MECKLENBURG COUNTY HEALTH DEPARTMENT
ENVIRONMENTAL HEALTH DIVISION

Application for an
Installation, Construction, Alteration, and/or Repair Permit
(Individual Septic Tank System with Subsurface, Soil Absorption, Effluent Discharge)

MECKLENBURG COUNTY
DEPARTMENT OF ENVIRONMENTAL HEALTH
INSTALLATION, CONSTUCTION, ALTERATION, AND/OR REPAIR PERMIT
(Individual Septic Tank System with Subsurface, Soil Absorption, Effluent Discharge)

CERTIFICATE OF COMPLETION
CERTIFICATE OF APPROVAL

PLOT OF SYSTEM

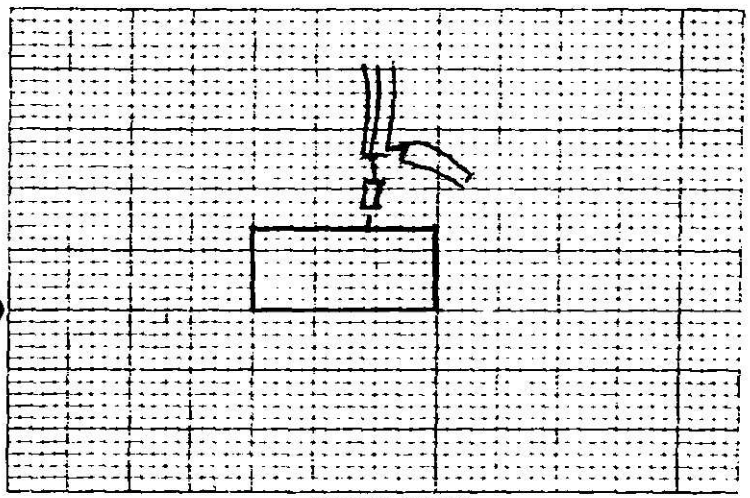
Comments: in bed 6 x 25' x 34" - recommend tank be cleaned
